DESIGN REVIEW & PRESERVATION BOARD
1231 "I" Street - SACRAMENTO, CALIFORNIA 95814

LOCATION: 511- 8th Street

PROPOSAL: The applicant proposes relocation of a Priority Structure from 317-11th Street, in the North Alkali Flat Preservation Area to the subject site in the Alkali Flat Preservation Area.

PB 87-02A

Scale 1/4" = 1' 0"	Drawn by <i>Richard A. Hendrick</i>	Check by <i>GBA</i>
Date 30 JUNE 87		
511 8th STREET PORCH PLAN		
Drawing number 5118FP/E

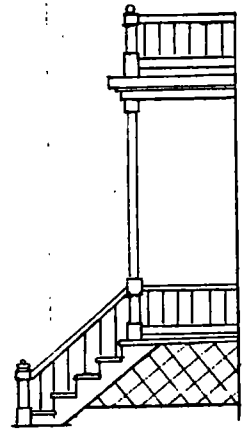
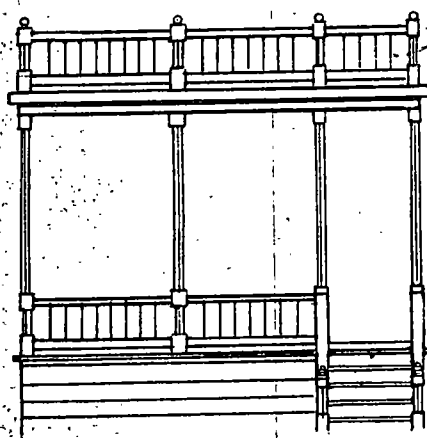
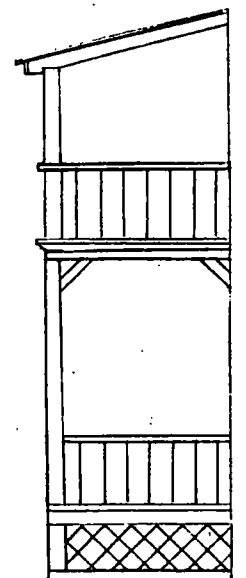
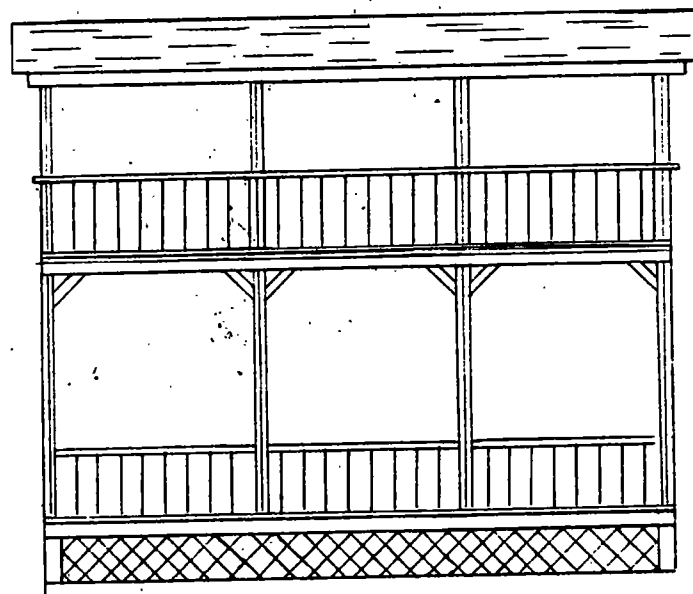
1. The Priority Structure proposed for relocation is presently without front and rear porches. The applicant's plans include new porch designs. Staff is supportive of the general layout of the porch and stairs. However, the detailing is inappropriate. Staff would prefer a 6" x 6" post with router cut camphered edges, with 2" x 6" mill finished banisters, 2" x 3" balustar and appropriate trim. The ball finial on the 2nd floor porch posts should be deleted.
2. The 2nd floor balcony should be made in accessible with the door replaced with a window to match the other two adjacent windows. Thereby, the railing could be provided at the height appropriate to the period without a secondary railing.

1. The porch detailing shall be redesigned for staff review and approval.
2. The second floor porch door shall be replaced with a window matching the existing windows.
3. Repair materials shall match the existing.
4. Colors shall be subject to staff review and approval.
5. Detailed landscape and irrigation plans shall be submitted for review and approval by staff.
6. Parking lot design shall be submitted for staff review and approval prior to issuance of building permit for the house.
